Editor's note:

This text is the output from the 10GBASE-T ad hoc in response to comment #186 on draft 2.1.

This document provides text to specify:

- (1) a EEE LPI link monitor capability**
- and**
- (2) a EEE fast retrain capability.**

Figure 55–24—PHY Control state diagram

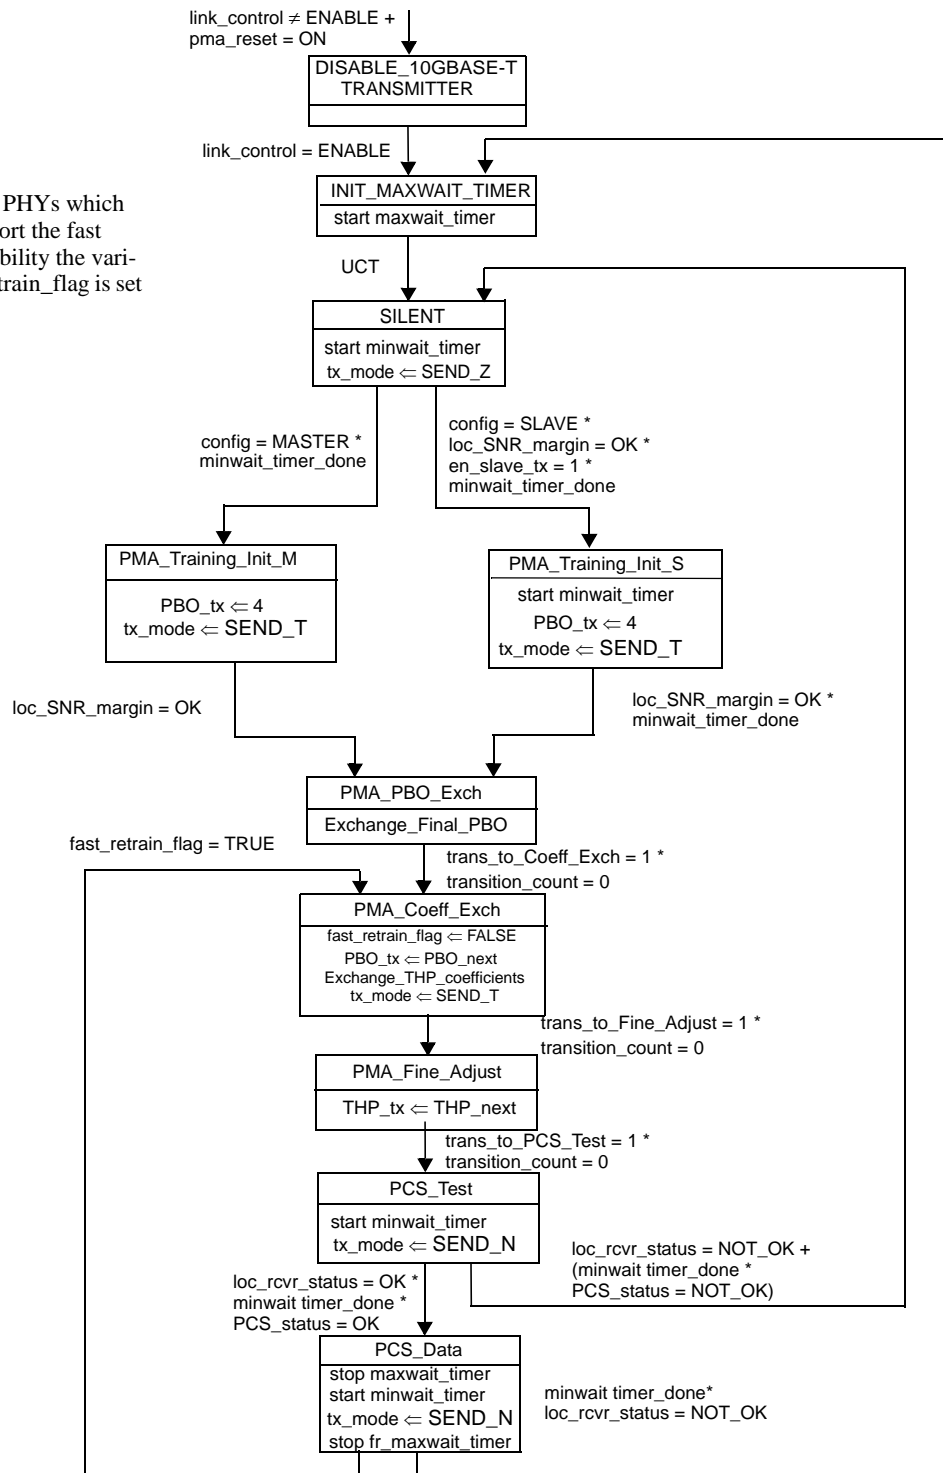
NOTE: For PHYs which do not support the fast retrain capability the variable fast_retrain_flag is set to FALSE

Figure 55–25—MASTER transition counter state diagram

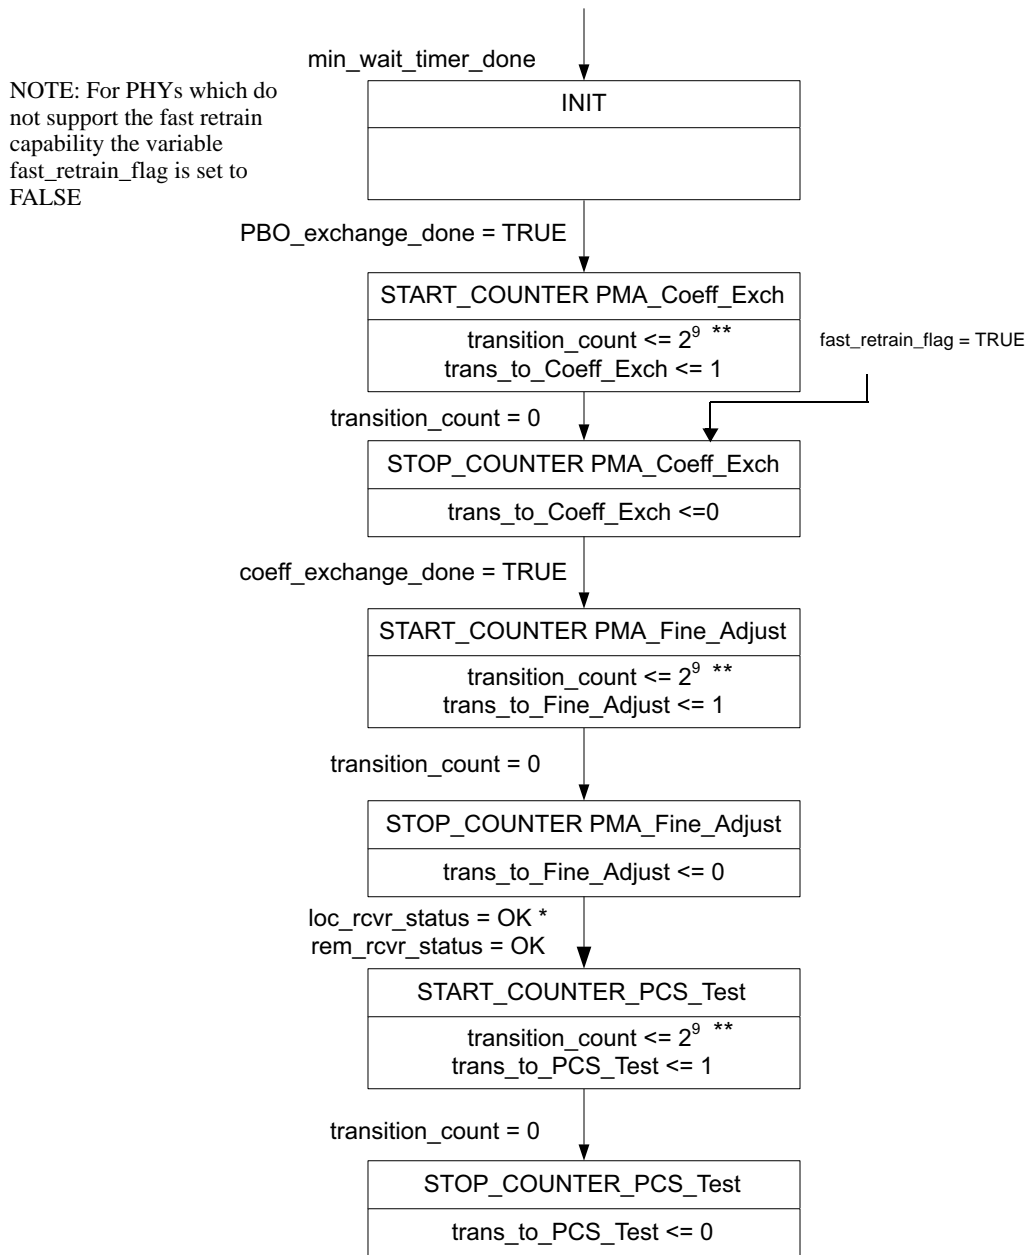
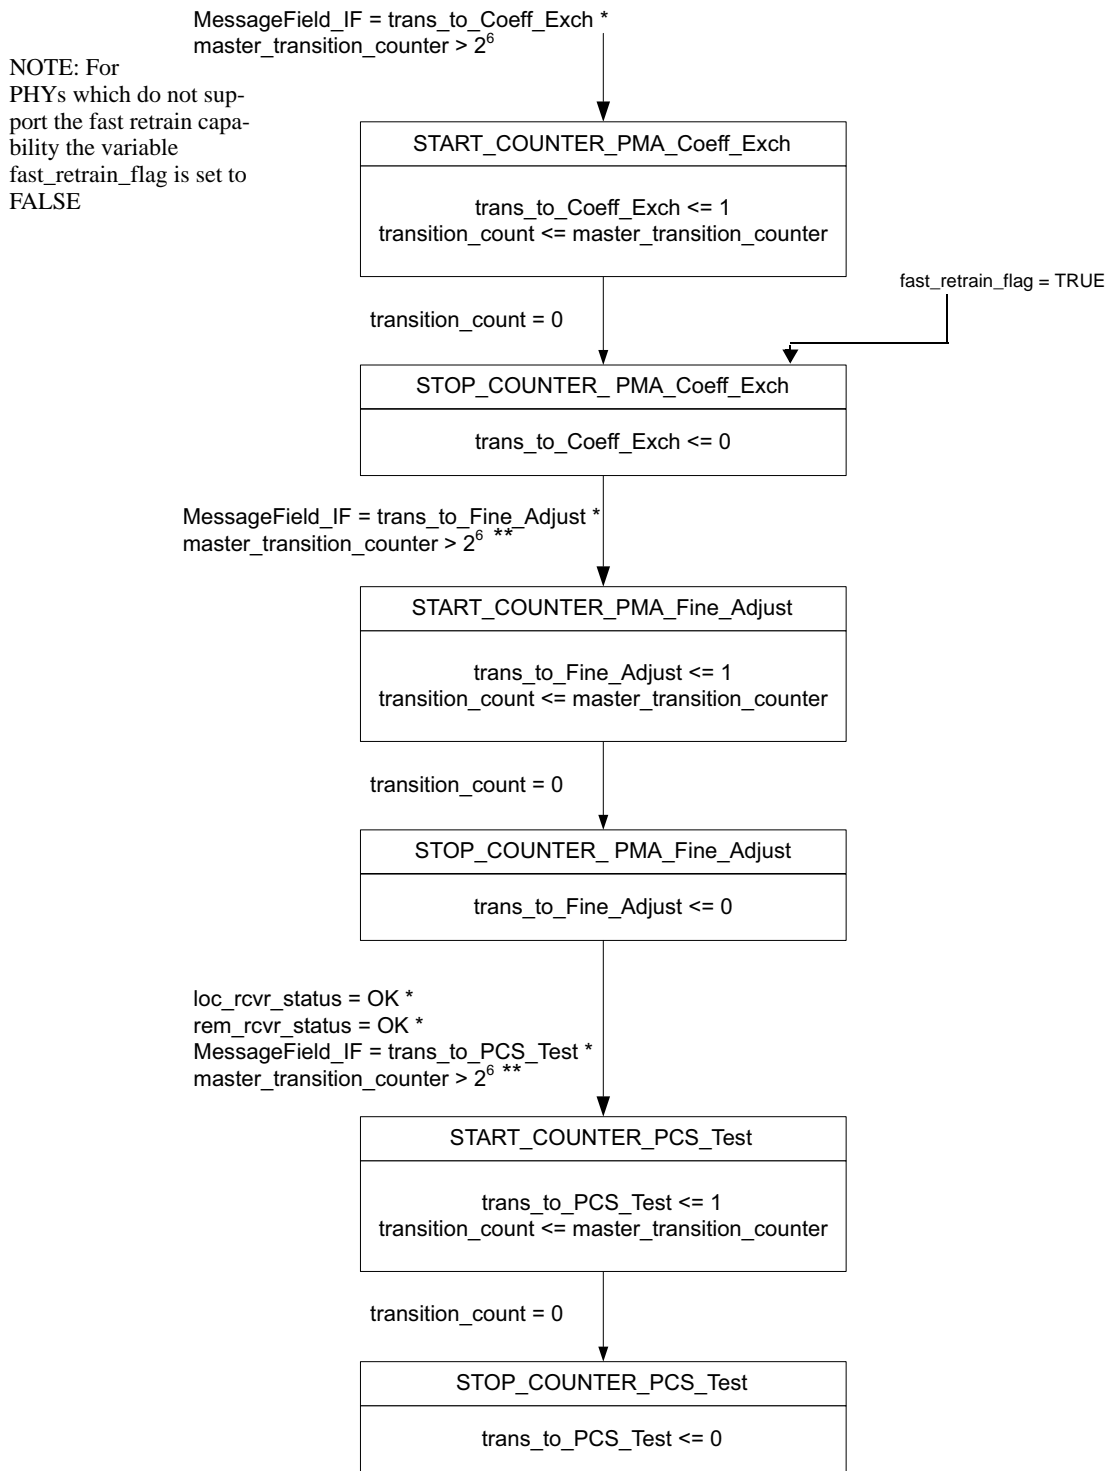
Edit the existing state diagrams in 55.4.6.2, Figure 55–25 and Figure 55–26, as shown

** - devices with fast retrain enabled use 2⁵

** - devices with fast retrain enabled use 2⁴

Figure 55–27a—EEE Refresh monitor state diagram

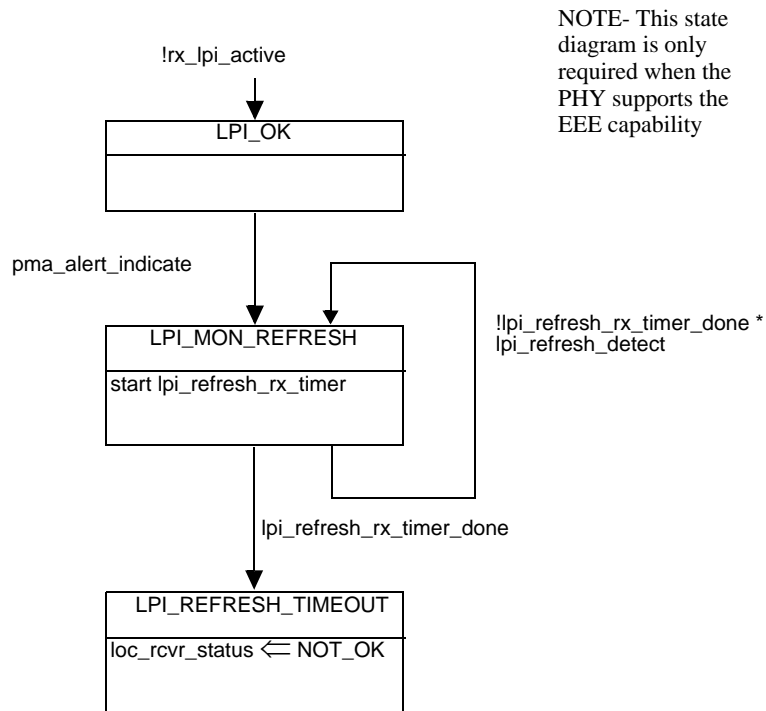
The Refresh monitor is required for PHYs which support the EEE capability. The Refresh monitor operates when the PHY is the low power receive mode. The Refresh monitor shall comply with the state diagram of Figure 55–27a. The function forces a link retrain if a refresh signal is not reliably detected within a moving

Insert a new subclause 55.4.6.4 after subclause 55.3.6.3, containing Figure 55-27a, as shown below

Figure 55–27b—Fast retrain control state diagram

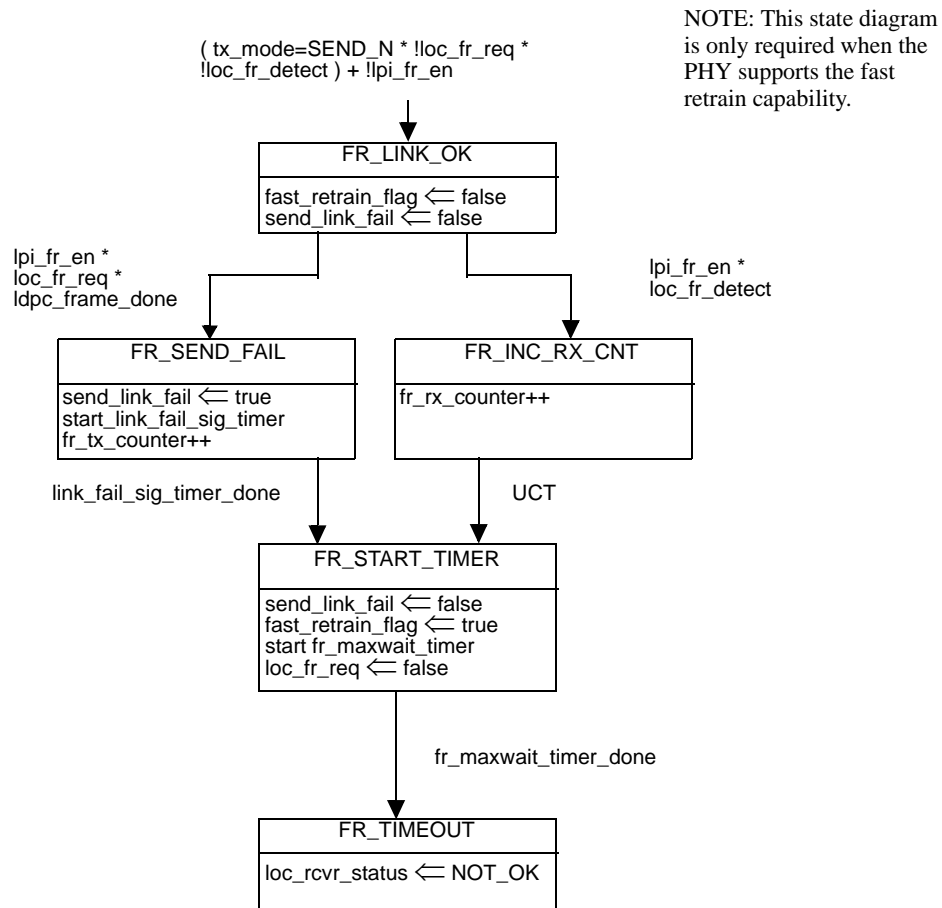
PHYs that support the fast retrain capability shall implement the fast retrain state diagram shown in Figure 55–27b. PHYs may request a fast retrain by setting the variable loc_fr_req to TRUE. This causes the transmission of an easily-detected link failure signal. After transmitting the link failure signal the PHY shall transition to the PMA_Coeff_Exch state and send PAM2 signaling within a time period equivalent to 9 LDPC frame periods after completing the link failure signal.

Insert a new subclause 55.4.6.5 after subclause 55.3.6.4, containing Figure 55-27b, as shown below
